ITEM: 6.15	COMMITTEE OF ADJUSTMENT REPORT SUMMARY MINOR VARIANCE APPLICATION FILE NUMBER A337/22 9 BUCK'S PL WOODBRIDGE
-------------------	---

**COMMITTEE OF ADJUSTMENT REPORT
MINOR VARIANCE APPLICATION
A337/22
9 Buck's Pl Woodbridge**

ITEM NUMBER: 6.15	CITY WARD #: 3
APPLICANT:	2826765 Ontario Ltd.
AGENT:	Ian Robertson Design
PROPERTY:	9 Buck's Place, Woodbridge
ZONING DESIGNATION:	See below.
VAUGHAN OFFICIAL PLAN (2010) DESIGNATION:	Vaughan Official Plan 2010 ('VOP 2010'): "Low-Rise Residential"
RELATED DEVELOPMENT APPLICATIONS:	None
PURPOSE OF APPLICATION:	Relief from the Zoning By-law is being requested to permit a proposed single-family dwelling, swimming pool and circular driveway.

PLANS PREPARED BY APPLICANT

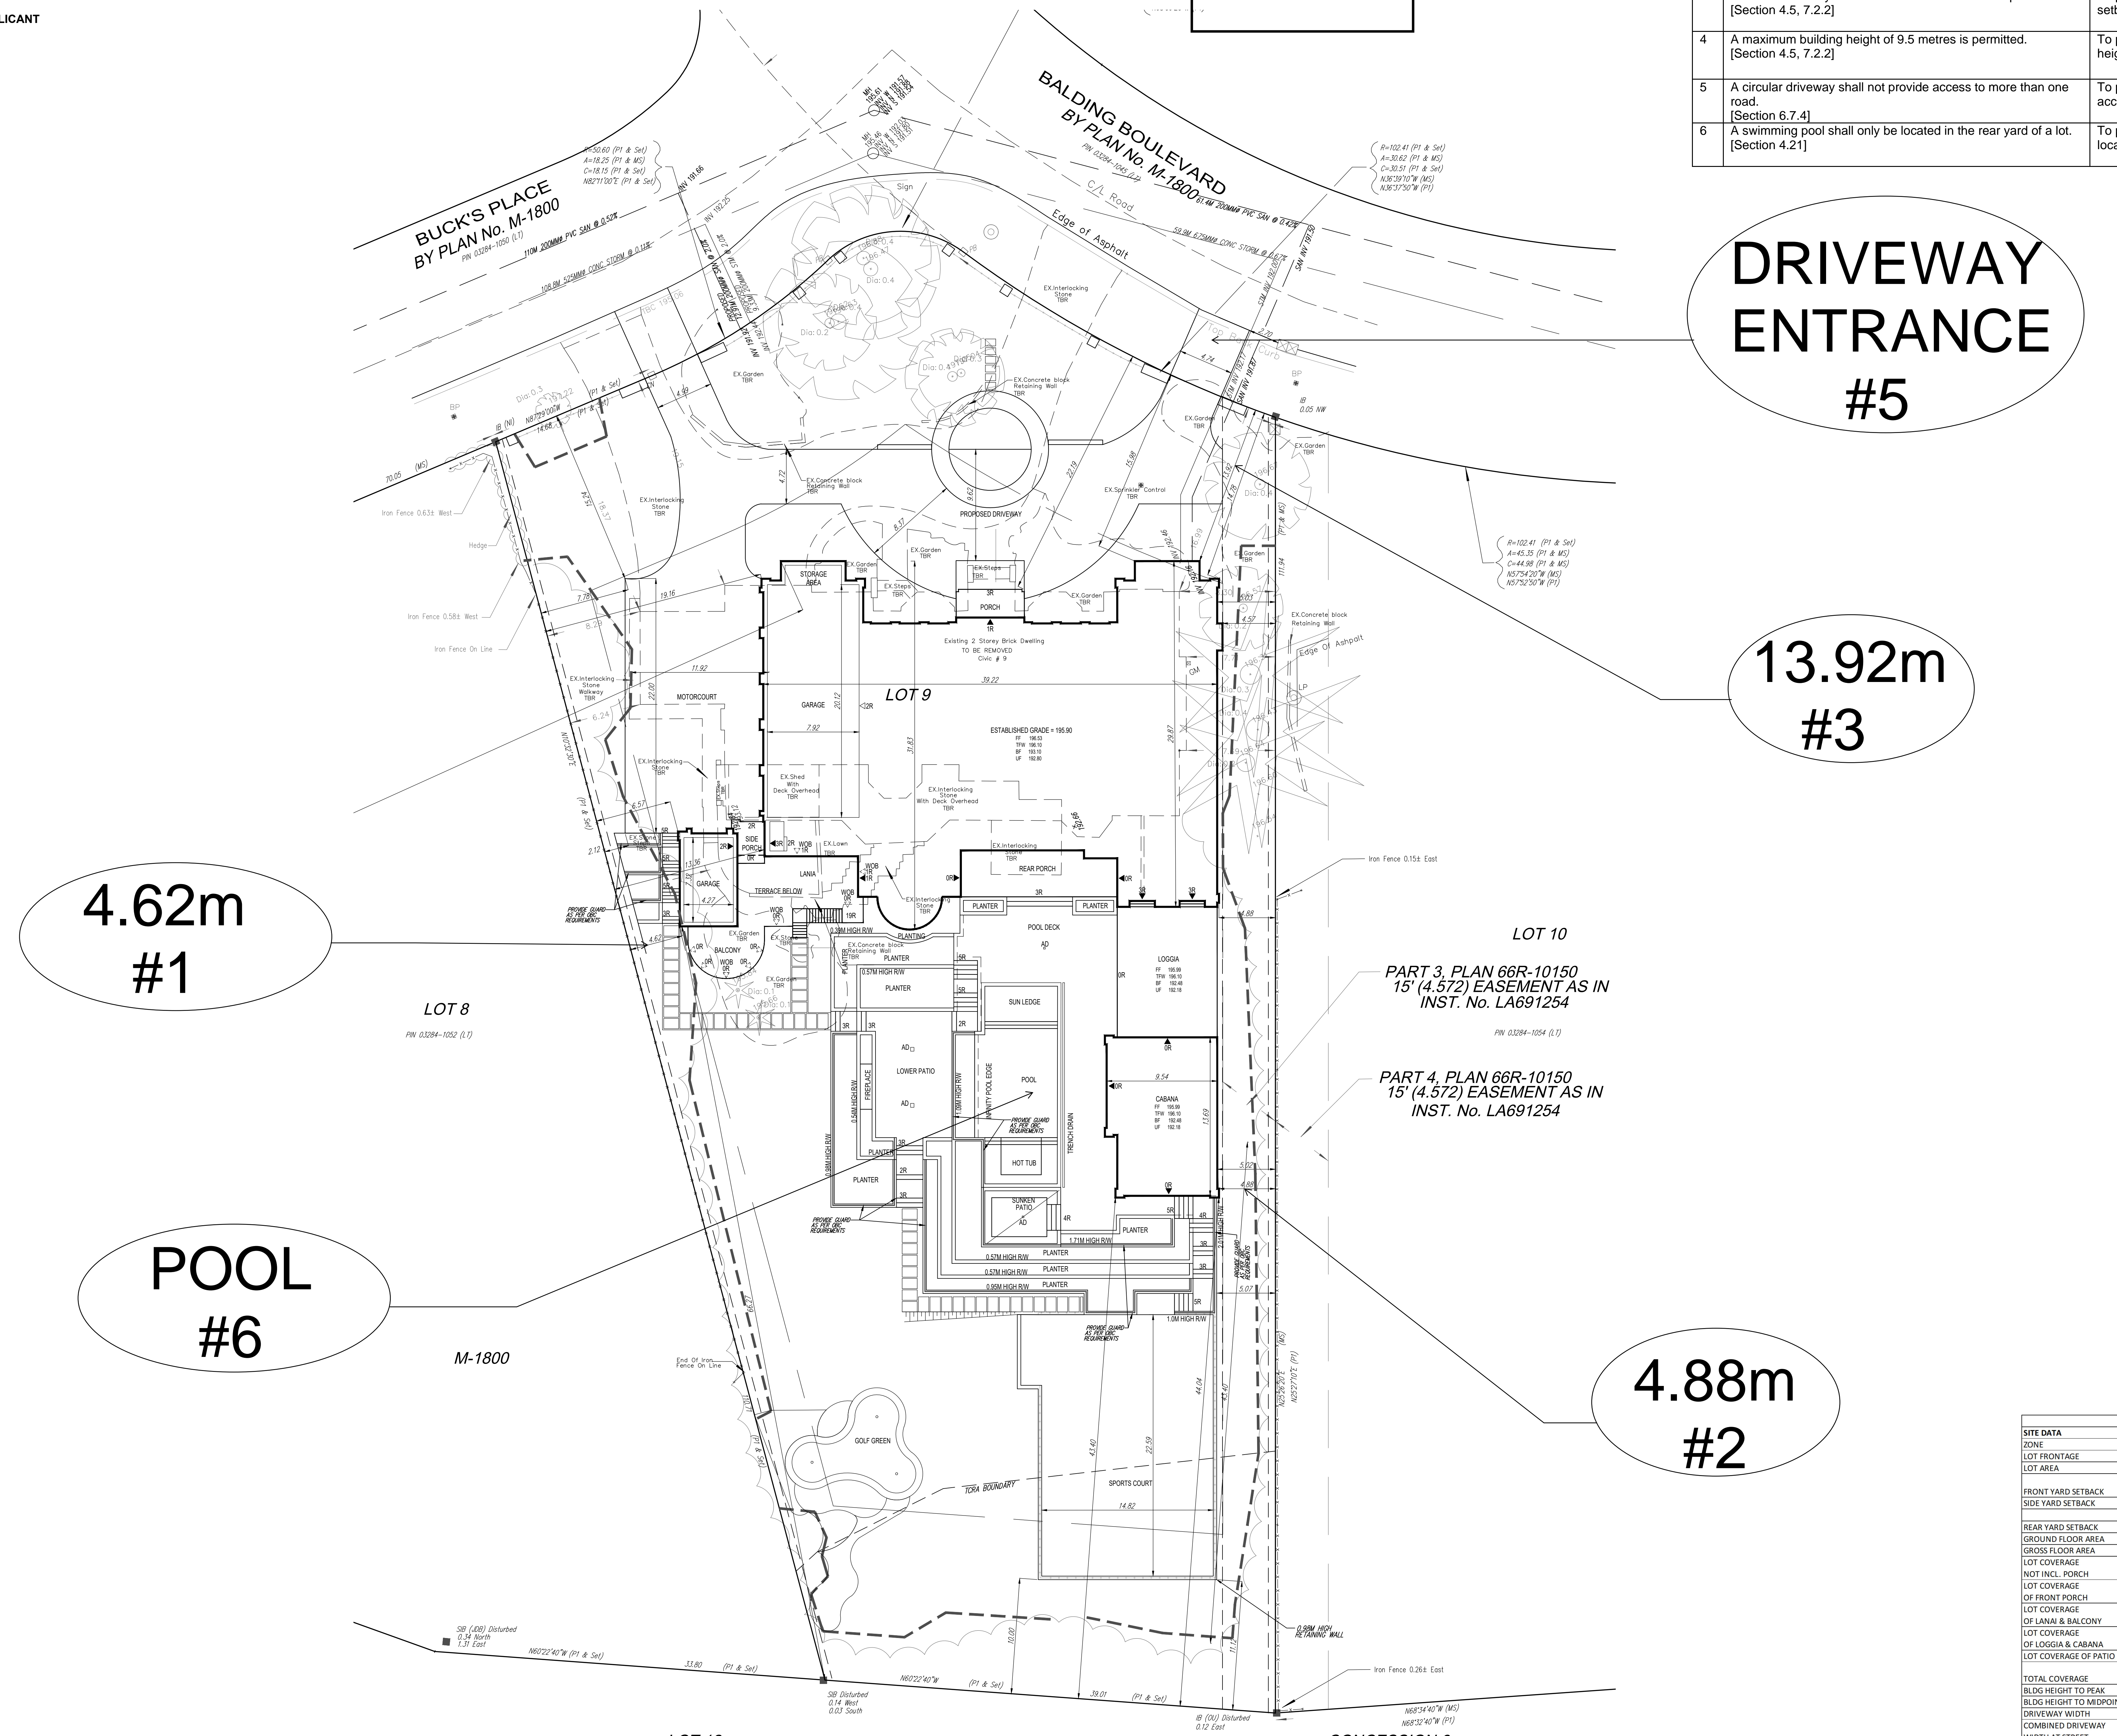
Based on a review of the submitted materials, the proposed sports court is located within TRCA's Regulated Area. As such, a permit pursuant to Ontario Regulation 166/06 will be required to authorize the works. Details related to TRCA's permit application have been provided in Appendix 'A' of this letter for the proponent's reference.

As noted above, the subject property is regulated by TRCA due to the presence of a valley corridor. Based on a review of TRCA's digital elevation mapping, the physical top of bank of the valley corridor encroaches approximately 3-7 metres into the rear of the subject property, generally corresponding with the 190 metres above sea level (masl) contour line.

TRCA policies require a 10 metre setback from the furthest limit of a valley corridor for all habitable structures (i.e., residential dwelling) and a 6 metres setback for all non-habitable accessory structures (i.e., pools, sheds, decks) and minor landscaping.

Based on a review of the materials submitted with this minor variance application, TRCA staff are satisfied that the proposed works are appropriately set back from the valley corridor. As such, TRCA staff have no objections to the requested variances.

1. That the applicant provides the required fee amount of \$660.00 payable to the Toronto and Region Conservation Authority.
2. That the applicant obtains a permit for the proposed works within the Regulated Area pursuant to Ontario Regulation 166/06.
